## 122G\_003 FM Modulation Modification Part A&B REV 002

There are two parts to this modification, Part A which deals with the microphone amplifier/ modulator and part B that restores FM tone modulation (if desired) when using an external reference.

**PART A**, Several component values are changed and 3 components are added. The modified microphone amplifier schematic is shown below :

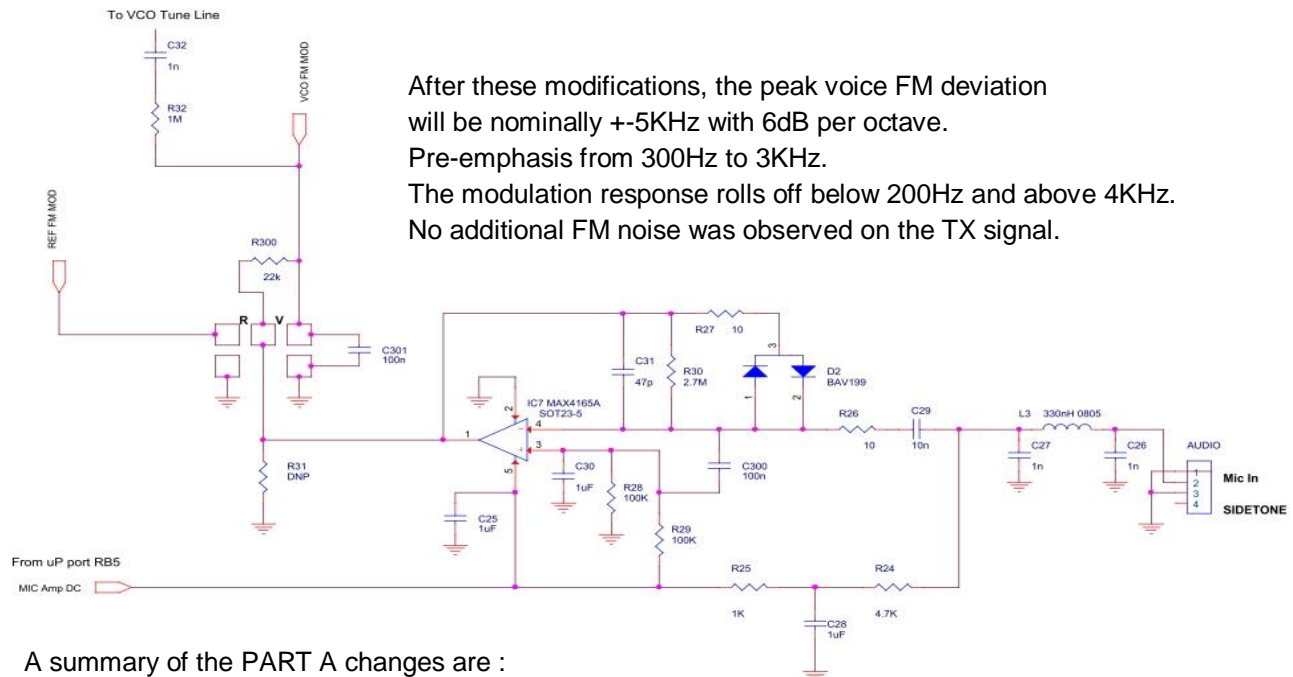
The original microphone amplifier has poor deviation peak limiting, insufficient microphone gain and an incorrect overall frequency response resulting in the FM modulation pre-emphasis being incorrect.

After these modifications, the peak voice FM deviation will be nominally  $\pm 5\text{KHz}$  with 6dB per octave.

Pre-emphasis from 300Hz to 3KHz.

The modulation response rolls off below 200Hz and above 4KHz.

### Bottom side of PCB prior to PART A modification

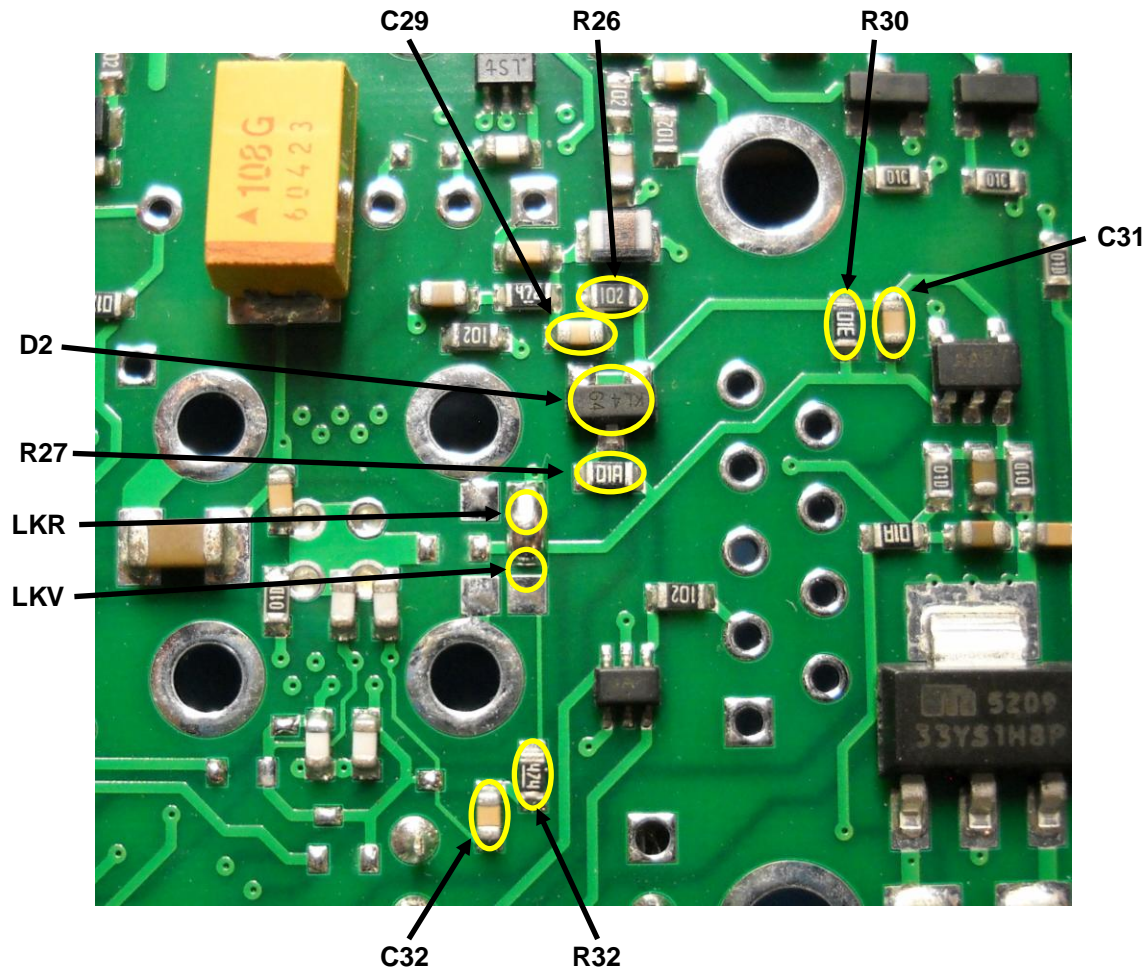
Refer to the image below to allow easy identification of the parts which are to be changed. The image shows the original PCB as supplied before modification.

C29 changed from 100nF to 10nF

R26 changed from 1k to 10 ohm

D2 changed from BAT54S to BAV199LT1G

R27 changed from 100 ohm to 10 ohm

R30 changed from 1M to 2.7M

C31 changed from 1nF to 47pF

R32 changed from 470k to 1M

C32 changed from 10nF to 1nF

Link LKR left open , Link LKV left open

Added parts C300 = 100nF , C301 = 100nF (1206) , R300 = 22k

### Bottom side of PCB after PART A modification

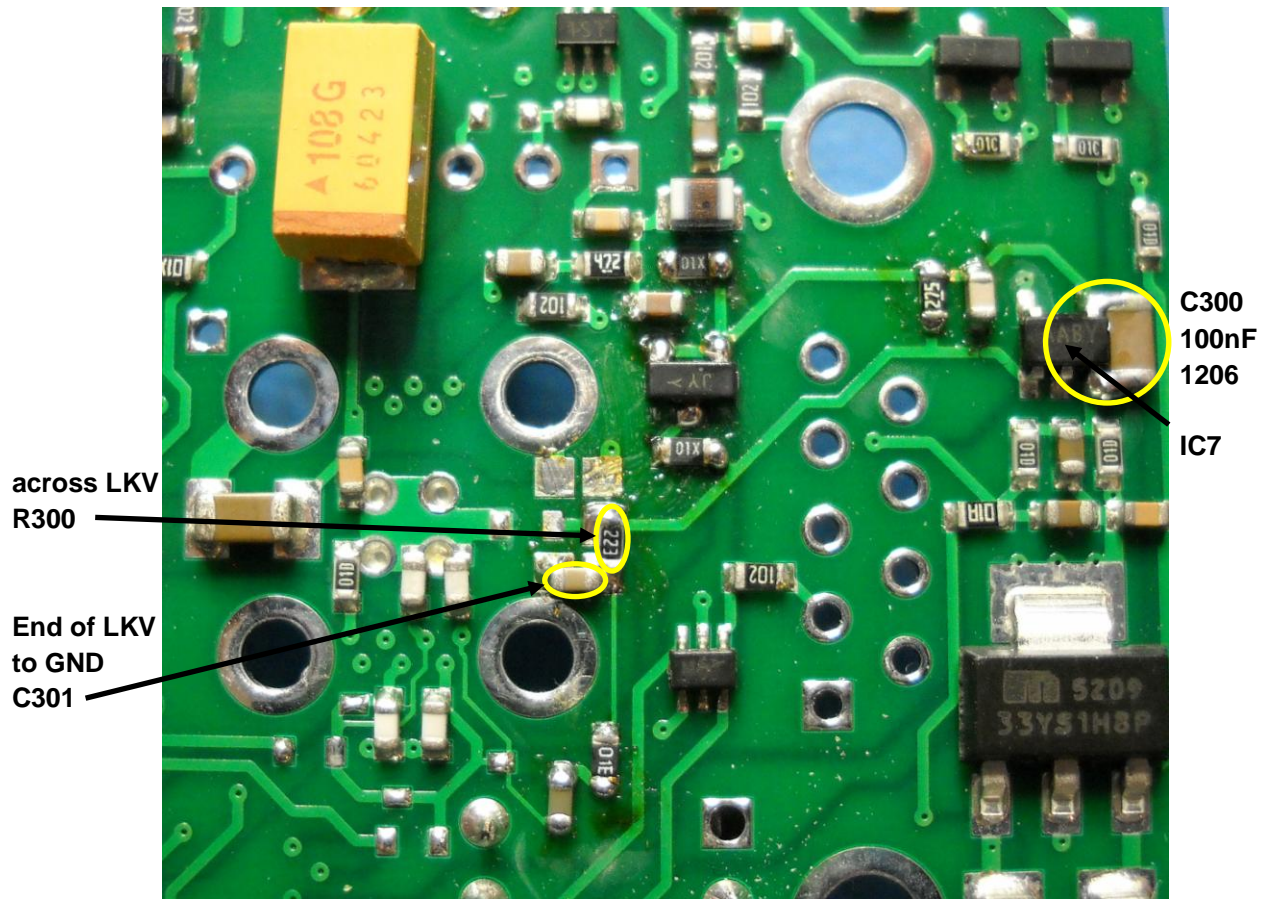
4 – Add C300 (100nF 1206) directly across pins 3 & 4 on IC7 (refer to the next image)

5 – Add R300 across the old link location LKV (refer to the next image)

6 – Add C301 between the end of LKV and the adjacent unused ground pad. (refer to the next image)

R300 is placed on the old link location LKV, C301 is placed from the end of LKV to ground. C300 is placed directly across pins 3 & 4 on IC7, directly beside the package of IC7.

**Note**, All capacitors and resistors are 0603 size except for C300 which is a 1206 size 100nF capacitor.

Bottom side of PCB prior to PART B modification (PART A already done)

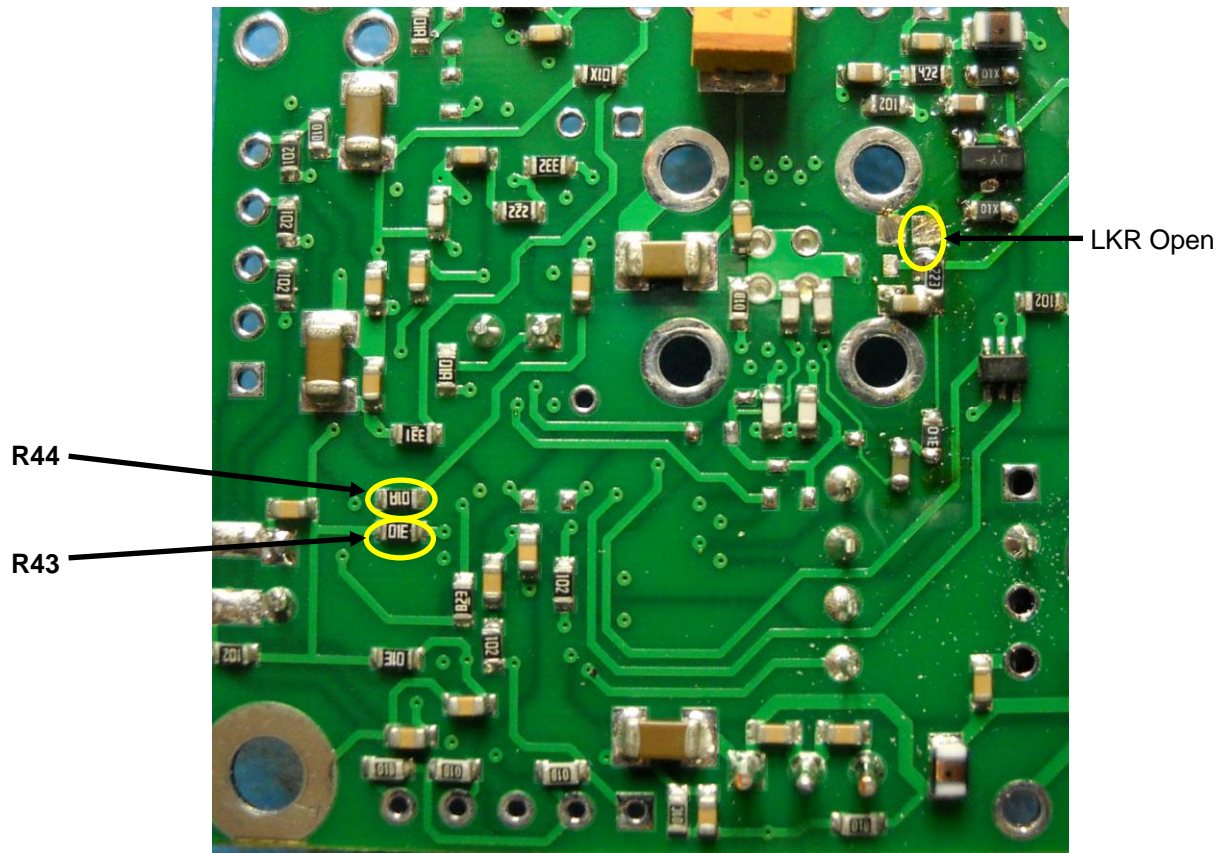
1 - Refer to the image below and locate R43 & R44 on the bottom side of the PCB which both need to be removed.

### Bottom side of PCB after PART B modification

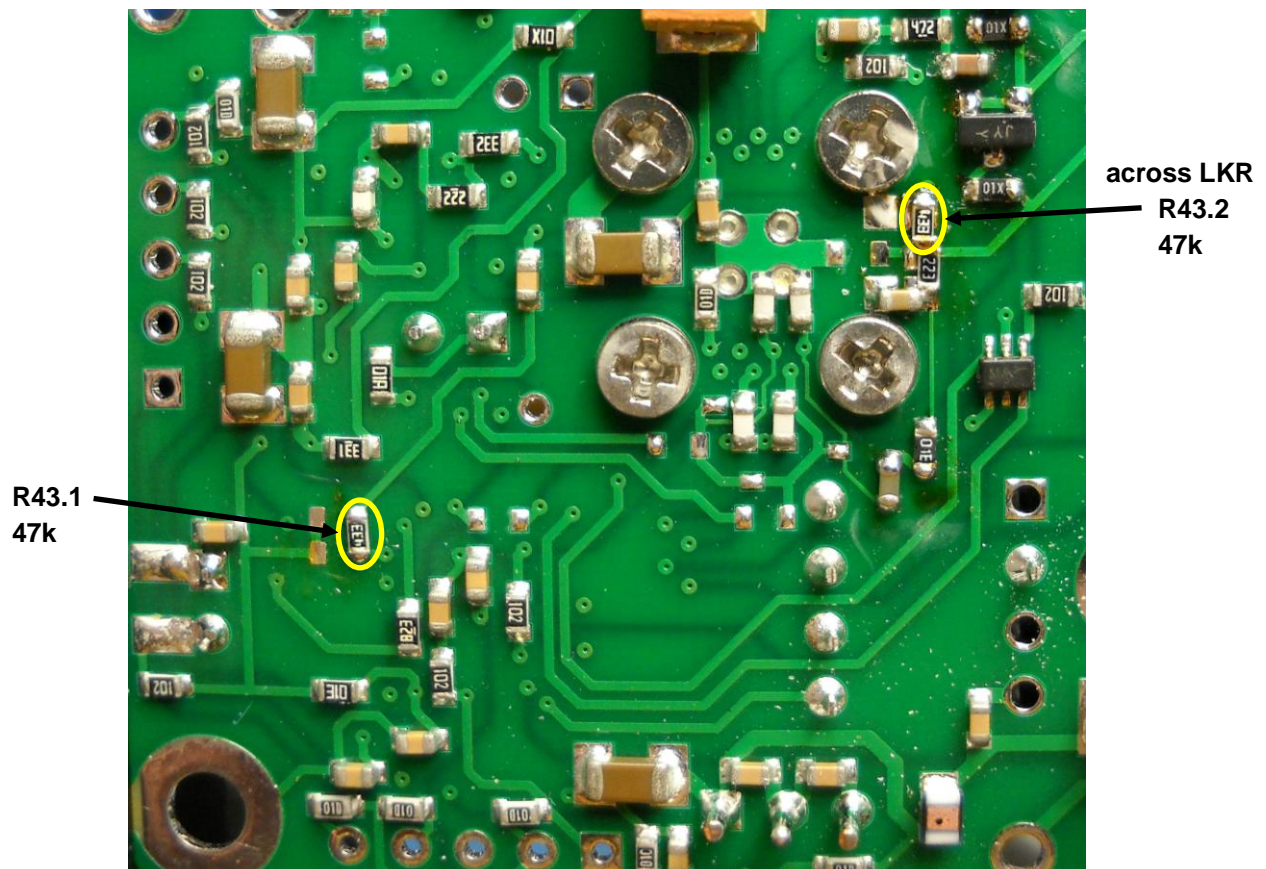
2 – Referring to the image below, place a 47K 0603 (R43.1) resistor on the two pads at the right hand ends of the old locations for R43 & R44.

3 – Referring to the image below, place a 47K 0603 (R43.2) resistor across the open link LKR

R43.1	47k, 0603
R43.2	47k, 0603
